Amendment No. 0002
26 June 2003

SUBJECT: Amendment No. 0002 to Request for Proposal Solicitation Package
Design and Construction of 37TH B1-B SQUADRON OPERATIONS FACILITY,
FXBM 99-3001, ELLSWORTH AFB, SOUTH DAKOTA.
Solicitation No. DACA45 03 R 0036.

Item Code: LS-6.A

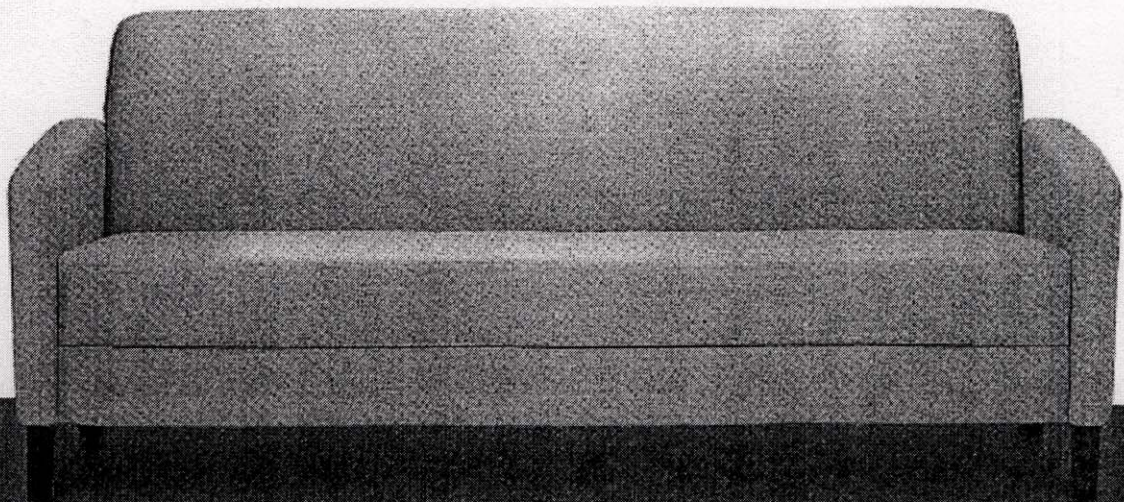
(19) Attachment 30, Part E, delete Furniture Illustration Sheet Pages showing Item Code LS-6.A, 9.A and substitute attached new Furniture Illustration Sheet Pages showing Item Code LS-6.A and LS-9.A.

Item Code: OT - 1.A, 2.A

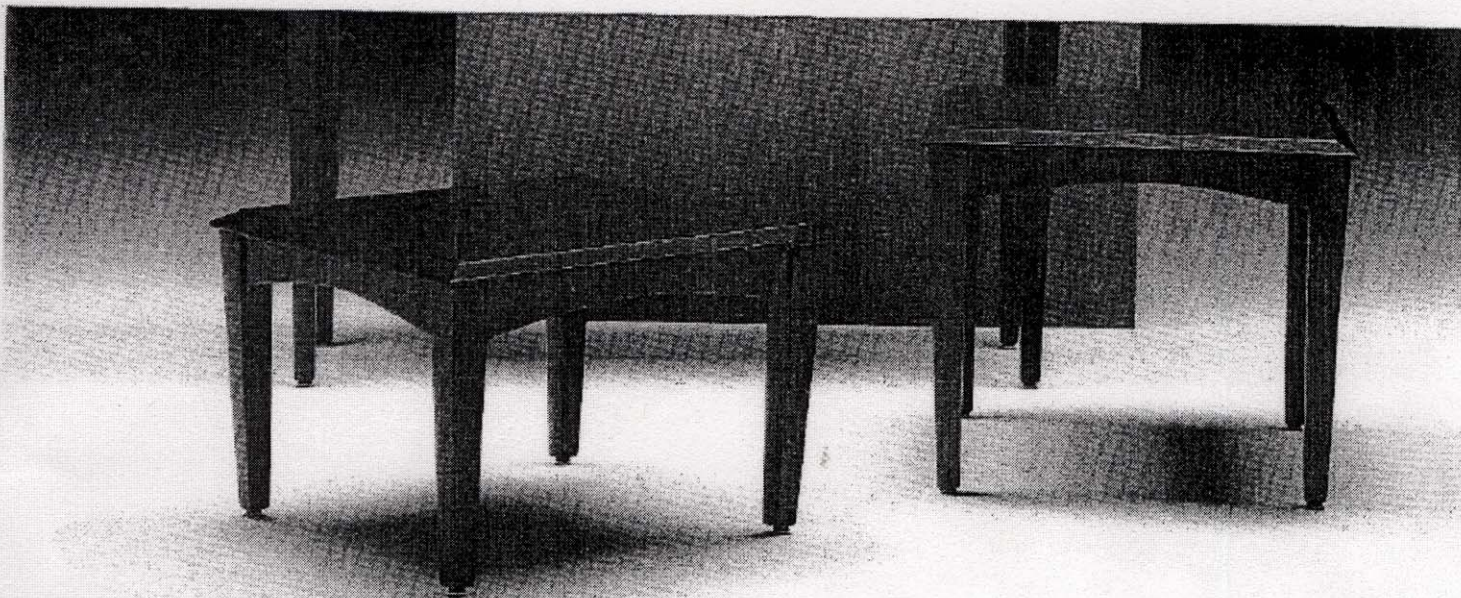
(20) Attachment 30, Part E, delete page showing Furniture Illustration Sheet page showing Item Code OT-1.A, 2.A and substitute attached new Furniture Illustration Sheet page showing Item code OT-1.A, 2.A.
